UNITED STATES PATENT AND TRADEMARK OFFICE

Office Action Summary	Application No. 10/002,811	Applicant(s) STRAND, AARON L.	
	Examiner Stephen Choi	Art Unit 3724

DETAILED ACTION

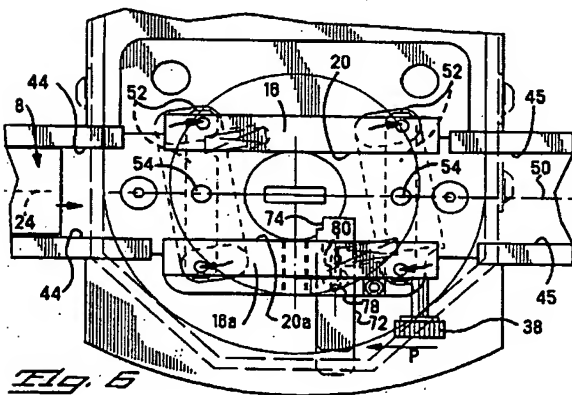
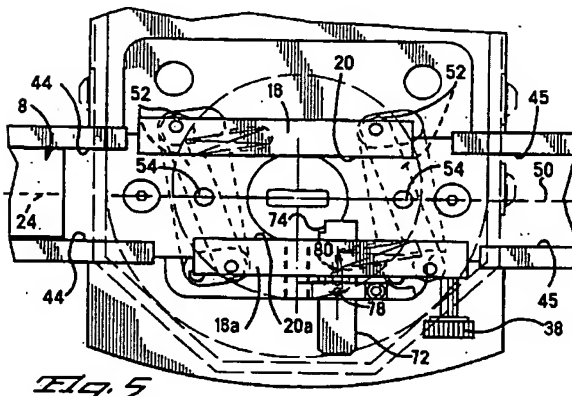
Fitz discloses all the recited elements of the invention including:

a) a housing (2) having a first slot, a second slot, and an open region (at 42);

b) a punch (3);

c) a guide slideable into the open region wherein the guide entering the open region in a plane that is generally parallel to the slot plane (see Figure below, the guide (16, 16a) is adapted to be slideably converge from the position shown on Figure 6 to the position shown on Figure 5 that is further into the open region). Regarding claims 13 and 30, the guide having a stepped edge (16, 16a, Figure 4). Regarding claims 17-19 and

24, the punch can be adapted to create a notch and edges as claimed and the guide can be adapted to engage at least one of tracks as claimed.

As pointed out above, the guides of Fitz are adapted to be slideably converging from the position shown on Figure 6 to the position shown on Figure 5 that is further into the open region. The claim does not preclude the guides being always located in the opening. The claim merely requires "a guide slideable into said open region". The guides of Fitz are adapted to be slideable further into the open region.
